UNITED STATES
NUCLEAR REGULATORY COMMISSION
WASHINGTON, D. C. 20555

SAFETY EVALUATION BY THE OFFICE OF NUCLEAR REACTOR REGULATION
AUDIT OF THE OCONEE-1/-2/-3 DESIGN FOR THE
RESOLUTION OF IE BULLETIN 79-27 CONCERNS
DUKE POWER COMPANY
OCONEE NUCLEAR STATION, UNITS 1, 2 AND 3
DOCKET NOS. 50-269, 50-270 AND 50-287

Diagram 1. Non-Class 1E 120-Vac Computer Power Panelboards KU

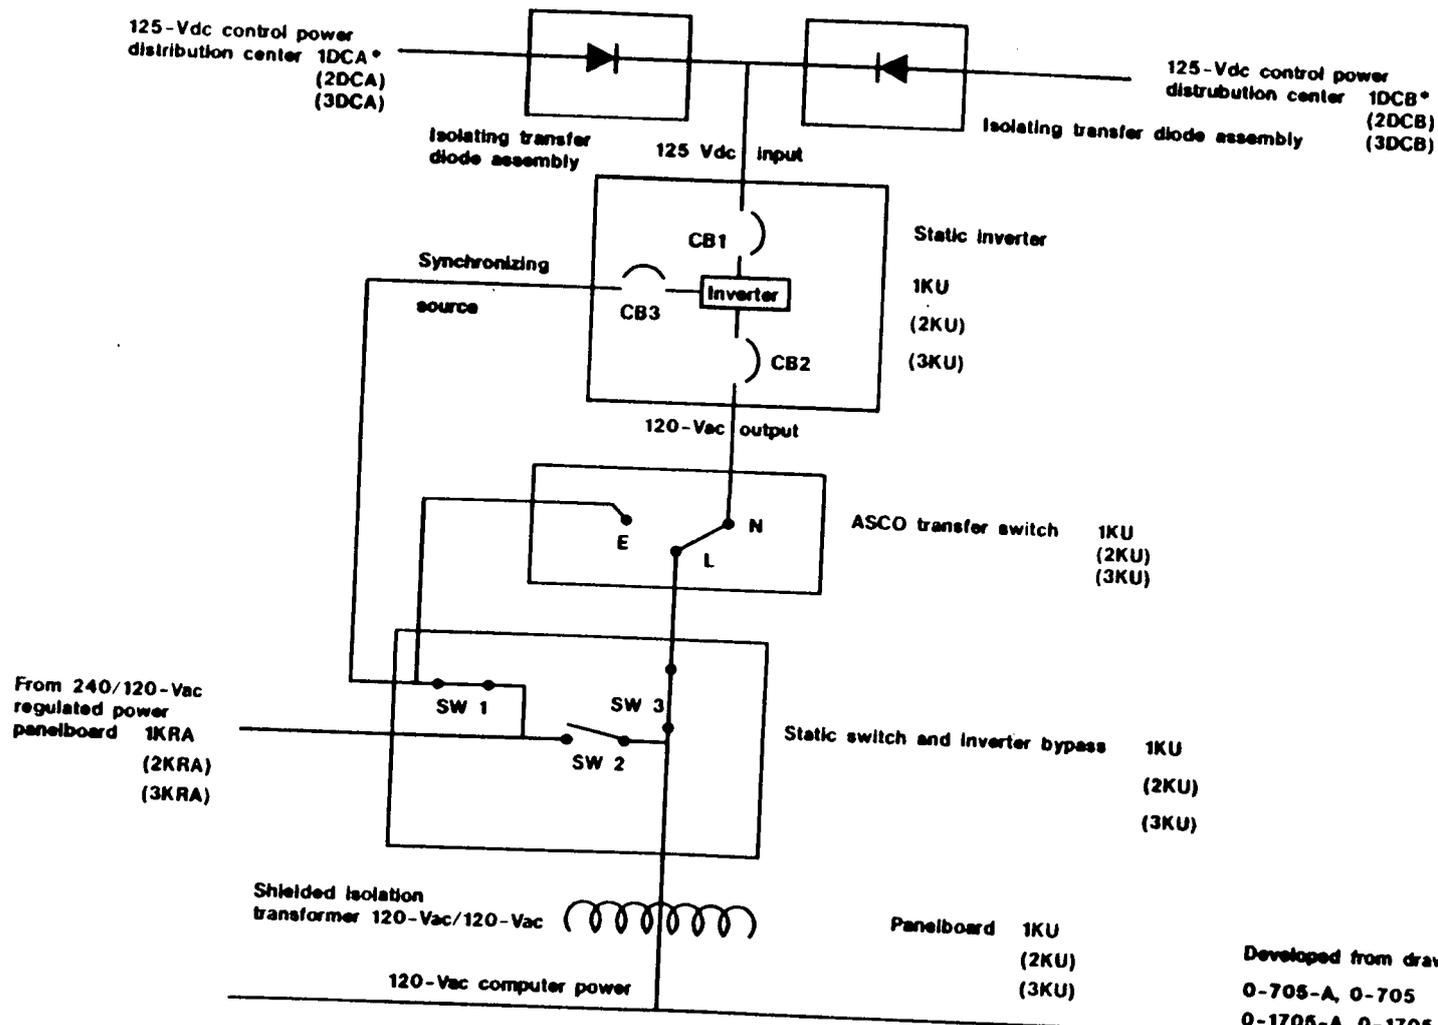
The Oconee Station has essentially identical 120-Vac computer power panelboards; 1KU in Unit 1, 2KU in Unit 2, and 3KU in Unit 3 (Diagram 1). Panelboard KU supplies a significant number of loads that are required to be operable by shutdown and cooldown procedures. Major loads supplied by the KU panelboards are two annunciator panels called 'Statalarm', the plant computer (including input/output and display devices), and nuclear instrumentation (source, intermediate, and power range) recorders. The KU panelboards are also a source of backup power to the ICS.

The KU panelboard normally receives power from the KU inverter. 125-Vdc power is supplied to the KU inverter through two isolating transfer diode assemblies. The diode assemblies consist of a fuse-protected series/parallel network of diodes. The assemblies are so connected to isolate the two dc power sources from each other. The diodes and fuses are continuously monitored; an alarm occurs if a component fails. Other alarms monitor the input and output circuit breakers, and control power for the monitor and indicating circuits. Should the KU inverter fail, an alternate, regulated AC power source is accessed by either a built-in automatic static transfer switch (not shown in Diagram 1), an external ASCO transfer switch, or a manual transfer.

The loss of power to KU panelboard is annunciated on its unit 'Statalarm'. The 'Statalarm' power source is independent of the KU panelboard, and will not be affected by the loss of the KU panelboard power. An undervoltage relay on the KU panelboard operates the annunciator module. The response procedure for this alarm lists the manual actions to be performed by the operator (Appendix A).

The KU panelboards supply power to display groups 04 and 16 of the operator aide computer in their respective units. These display groups are transferred to panelboard OAC on the loss of the panelboard KU power source, thus assuring the availability of these displays. The nuclear instrument recorders will also be lost due to the loss of KU panelboard. However, the operator will have indications from individual channels to help him follow the plant shutdown procedure.

Indication of the 1B (2B or 3B) core flood tank outlet valve position is lost with the loss of KU panelboard. This valve is locked in the open position while the unit is operating. Power is still available to close the valve in the normal manner.

To prevent inadvertant core lift when starting a reactor coolant pump, the operator normally observes the cold leg temperature. With the loss of this instrumentation caused by the loss of the KU panelboard, the in-core thermocouples are still usable. Operator training is provided for this alternate method of core lift protection.

Based on the above design features, plant operating procedures, and operator training, the audit team concluded that following the loss of power to the KU panelboards (1KU for Unit 1, 2KU for Unit 2, and 3KU for Unit 3), the operator has sufficient instrumentation, indication, and equipment available in the control room to achieve cold shutdown using the approved procedures.

Diagram 2. Class 1E 125-Vdc I&C Power Panelboards DIB

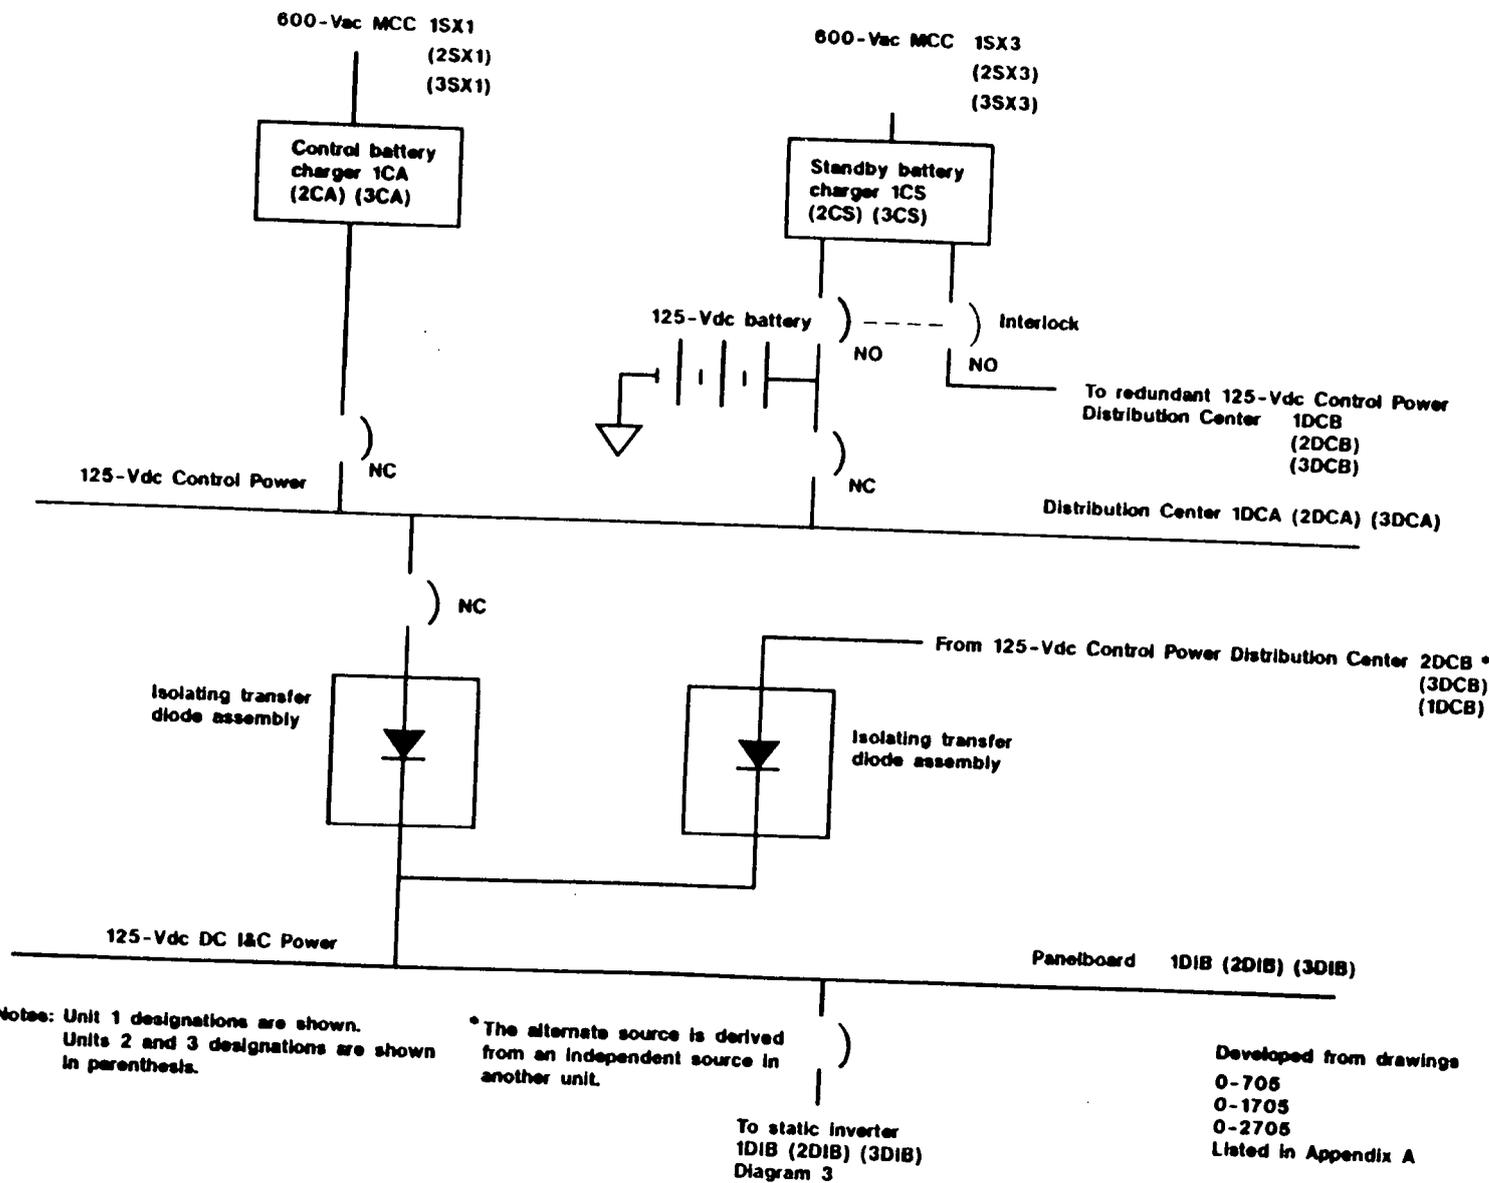
The Oconee Station has essentially identical 125-Vdc instrument and control power panelboards; 1DIB in Unit 1 ; 2DIB in Unit 2, and 3DIB in Unit 3 (Diagram 2). Panelboard DIB supplies a significant number of loads that are required to be operable by shutdown and cooldown procedures. Major loads supplied by this panelboard include the controls for the 'A' emergency feedwater pump, the 'B1' and 'B2' reactor coolant pumps, and the 'B' low pressure injection pump. The licensee stated that the protection scheme of all these loads use a second trip coil with the control power independent of the DIB panelboard. Thus, the operator would be able to trip these loads with no variance from normal procedures. The DIB panelboard also supplies power for the controls of the main turbine, the control rod drive controls, the DIB static inverter (discussed in Section 3.3), and motive power for the letdown isolation valve.

The loss of turbine controls caused by the loss of a DIB panelboard will cause a turbine trip. This, in turn, will cause a reactor trip. The operator is procedurally instructed to manually trip the reactor and the turbine generator as a backup operation for the postulated event. With the turbine trip, the licensee verified that the units power distribution system would successfully transfer from the unit generator to the offsite power. However, two reactor coolant pumps (B1 and B2) will not be operable due to control power loss which is acceptable with a reactor trip as the emergency operating procedure allows operation with one RCP per loop.

Long-term heat removal from the reactor coolant system is provided by one of the three low pressure injection (LPI) pumps. One LPI pump (pump B) will be

inoperable due to the loss of control power from panelboard DIB. However, LPI pump "A," backed up by pump "C" will be sufficient to provide long term reactor heat removal during plant shutdown.

The HP-5 letdown isolation valve in each unit is located outside of containment and fails closed on the loss of motive power from panelboard DIB. The licensee stated that there are upstream valves that can be manipulated to regulate letdown flow, however, it will be difficult to match the letdown and makeup flows. The licensee stated that in this case it would be possible and preferable to manually open the failed closed valve.

Based on the above design features, plant operating procedures, and operator training, the audit team concluded that following the loss of power to the 125-Vdc I&C power panelboard DIB, the operator has sufficient instrumentation, indication, and equipment available in the control room to achieve cold shutdown using the approved procedures.

Diagram 3. Class 1E 120-Vac AC Vital Instrumentation Power Panelboards KVIB

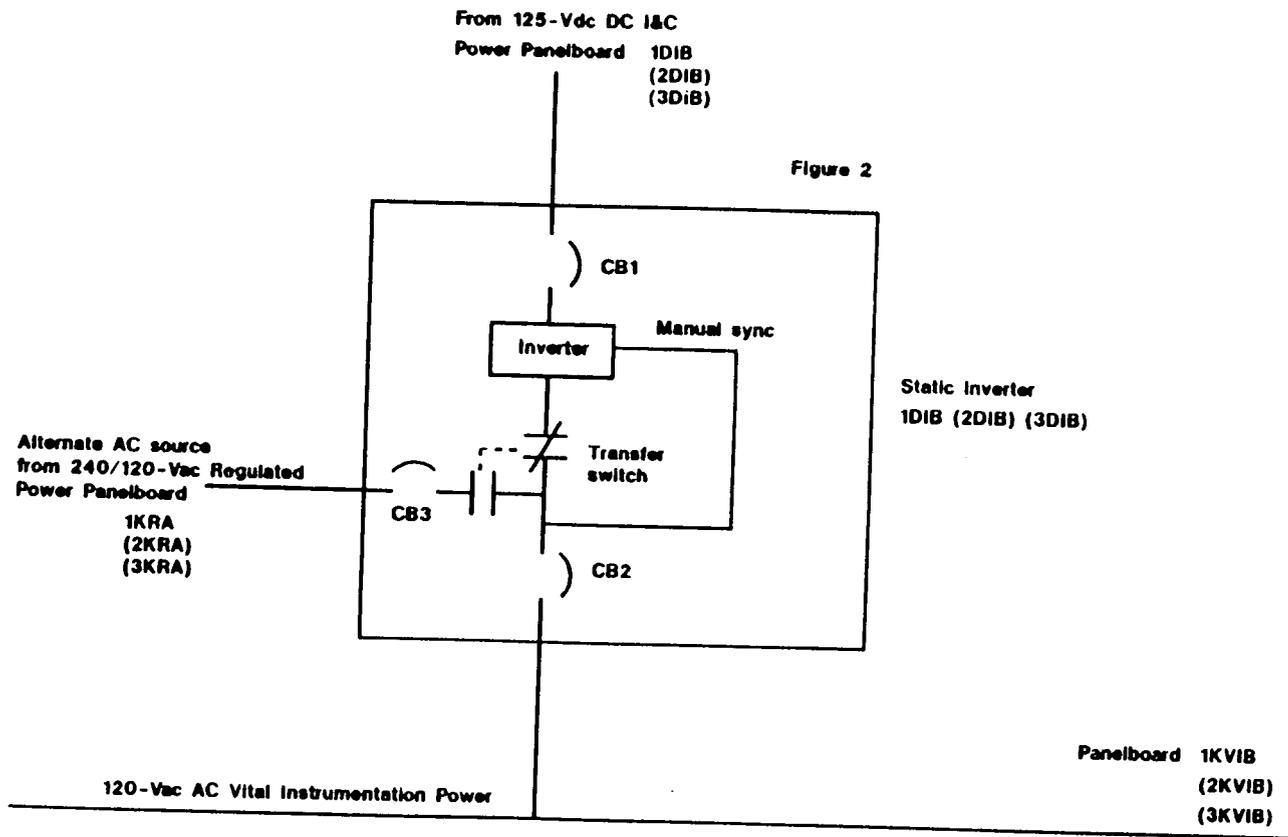
The Oconee Station has essentially identical 120-Vac vital instrumentation power panelboards; 1KVIB in Unit 1, 2KVIB in Unit 2, and 3KVIB in Unit 3 (Diagram 3). Panelboard KVIB is the source of power for the nuclear instrumentation, Reactor Protection System (RPS) channel B, portion of the Engineered Safeguards (ES) instrumentation (channel B), the steam generator level control cabinet, and the Reactor Coolant Pump (RCP) power monitor channel B. The KVIB panelboard is fed from a, a 9.3 KVA static inverter (DIB), that has an integral manual transfer switch. This transfer switch can be used to manually transfer the KVIB panelboard to the alternate power source (regulated power panelboard KRA) if the KVIB panelboard has lost its normal power source from the associated inverter DIB. Loss of power to the KVIB panelboard is not annunciated in the control room, however, annunciation of the trip of the RCP power channel B monitor and the ES instrument system channel B would provide indirect indication of loss of power to this panelboard.

RPS channel B and ES channel B will be tripped by the loss of power to KVIB panelboard. However, RPS or ES initiation will not occur as each system requires 2 channels to trip for actuation.

Loss of power to this panelboard does not affect the ability of the operators to achieve cold shutdown. Although many of the instruments and controls that receive power from this panelboard are procedurally needed for a safe unit shutdown, procedures and operator training are provided to assist in bypassing inoperable controls, manually controlling a normally automatic function, or relying on redundant instrumentation.

Based on the above design features, plant operating procedures, and operator training, the audit team concluded that following the loss of power to the KVIB 120-Vac AC vital instrumentation power panelboards (1KVIB for Unit 1, 2KVIB for Unit 2, and 3KVIB for Unit 3), the operator has sufficient instrumentation, indication, and equipment available in the control room to achieve cold shutdown using the approved procedures.
